Subject: Requesting Class II permissive change for FCC ID: TQYBMNF2301000M

The purpose of this letter is to request a Class II Permissive change for FCC ID: TQYBMNF2301000M, original granted on 06/19/2013

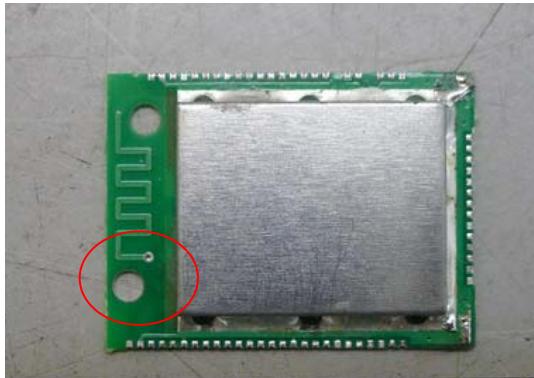
There is no hardware or electrical modification made to the applying modular transmitter itself. The Major changes filed under this application are:
Components around antenna changed which cause the antenna gain changed from -6.03 to -3.19dBi.

Before

After
